Ref: FCC Class II Permissive change for FCC ID: YRW-BLUELITEV2

Applicant: DATECS LTD.

This is to request a Class II Permissive change for FCC ID: YRW-BLUELITEV2 granted on 01/01/2020 (date).

Changes between PCB P210702 and PCB P210105

1. PCB Top and Bottom view

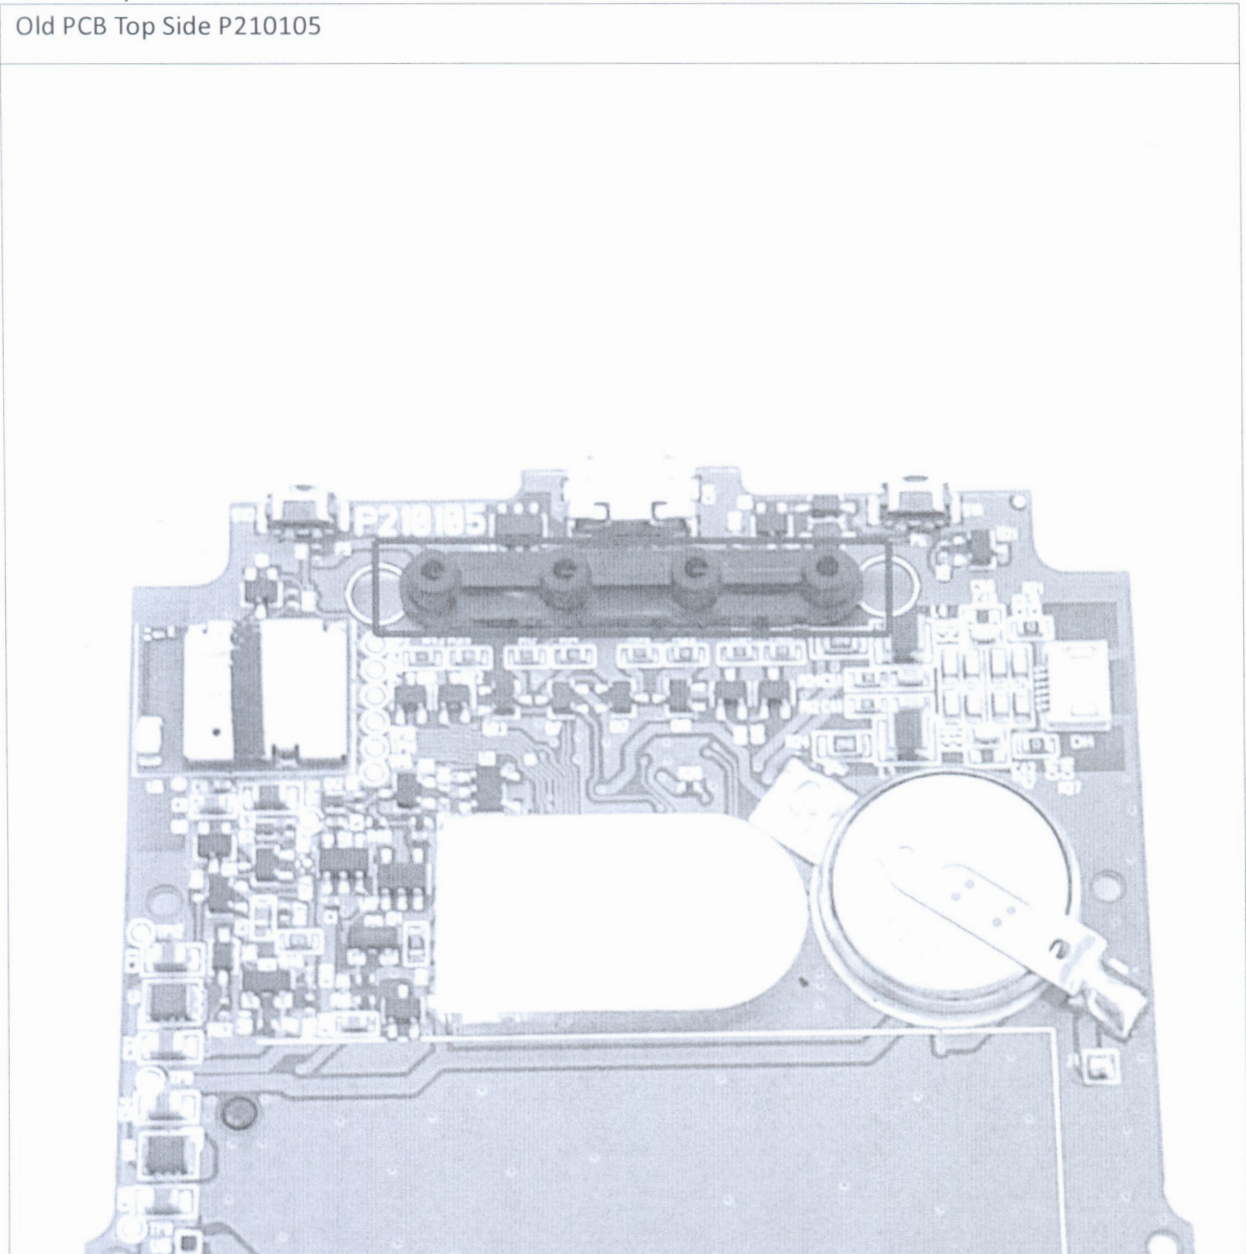
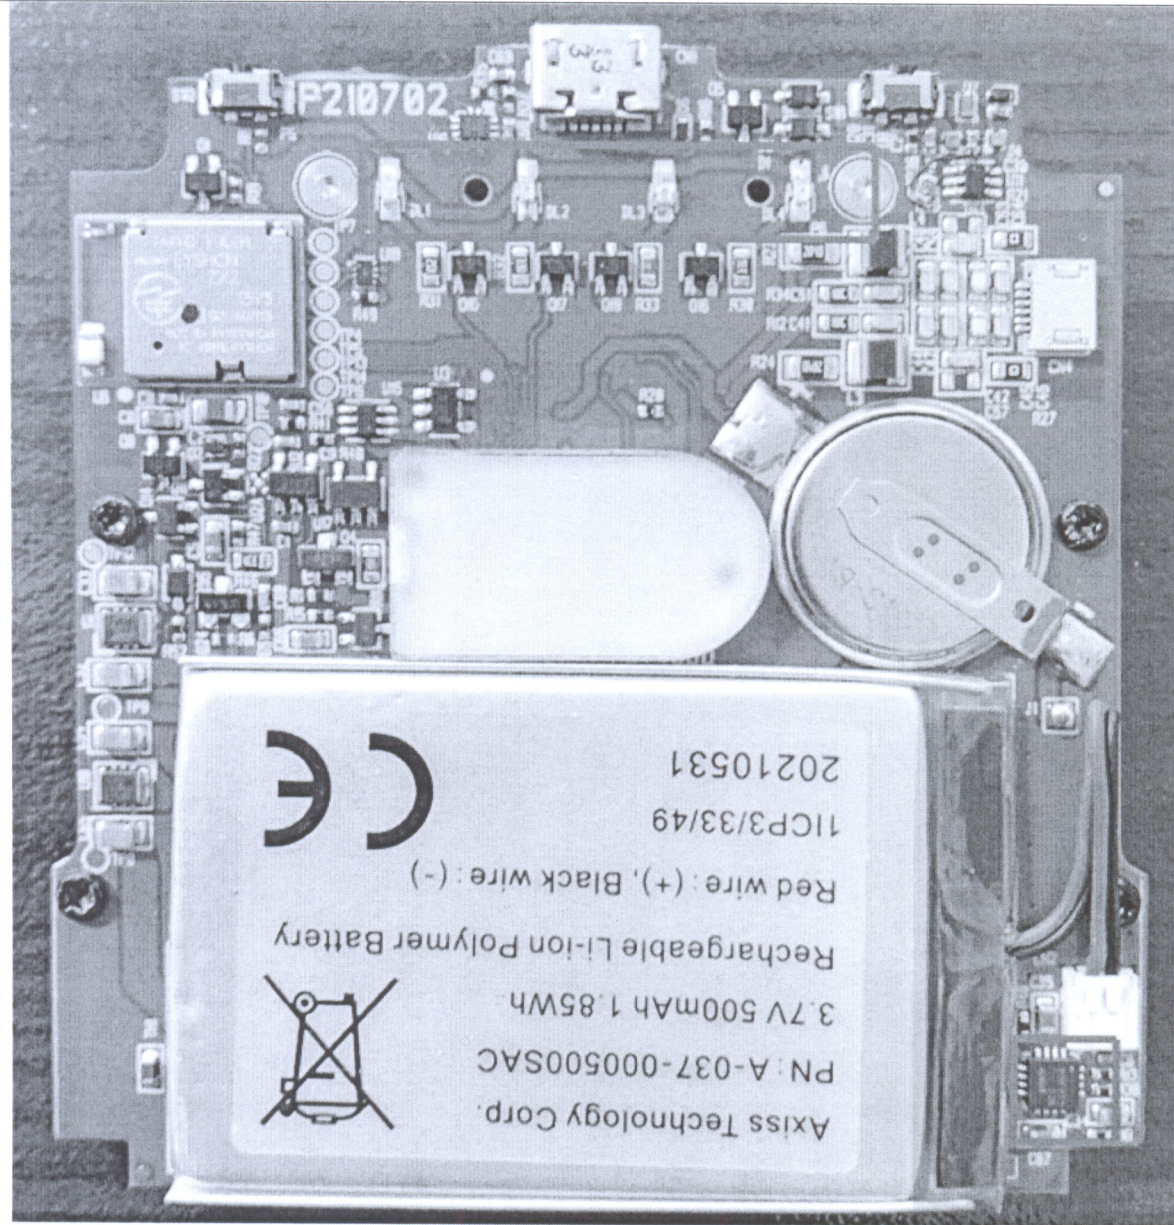
Changed Battery management chip from MAX8808X to BQ24075. This chip is for battery charging. Added new signal "CHRG_EN) for battery IC enable/disable. This if for battery charging control. Added signals SWDIO and SWDCLK between BT and MCU

Internal MESH in Layer 1 – rerouting changes. This MESH is a part from the security of the device.

Changed Buzzer from BMB-2703N to NFT-03D. For adding the CN6 was need space, for that reason is changed size of the buzzer. Buzzer is using for payment transaction status and device statuses.

Added connector CN6 – added possibility for charging device via rear pads. Also for USB communication over those pads. USB signal is switching between rear pads and USB type-C connector with switch U16. Added new PCB P211402 - Cradle Contact Board. Provides USB communication and charge.

NFC status LEDs will be two types: only green or multi color (G/Y/O/R) . They are using for Payment transaction status.
